City of Santa Fe, New Mexico

memo

2025-010949-HDRB, 913 ½ Acequia Madre, Downtown and Eastside Historic District, Contributing, Richard Martinez, agent for Rick Andrew and Diane Buchanan, owners, requests approval of rear portal roof change from parapet to metal corrugated roofing system, replace kitchen with garage, and minor alterations to a previously approved design plan. An exception is requested to 14-5.2(D)(6) roofs.

Figure 4. Approved and Proposed West Elevation.

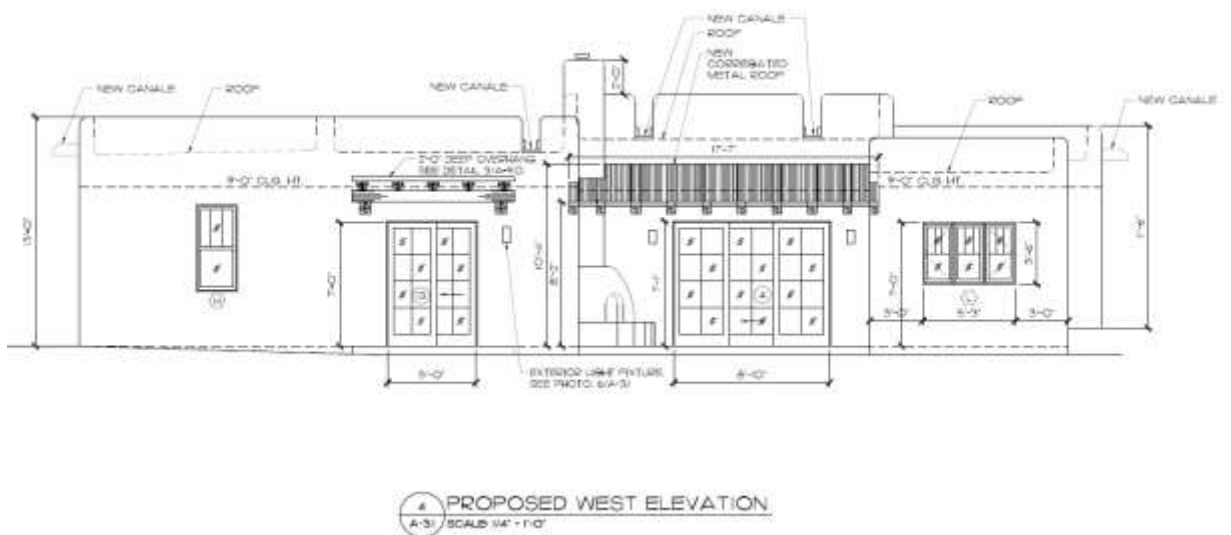
- 1) Construct a portal on the west elevation with a metal roofed instead of a parapeted roof with an outdoor fireplace.
- 2) Replace part of the rear Portal with the Kitchen.
- 3) Replace the Kitchen with a Garage.

Staff recommends approval of the proposed project and finds that no exception request is necessary and that the application complies with Section 14-5.2(D) General Design Standards for all Historic Districts, and 14-5.2(E) Downtown and Eastside Design Standards.
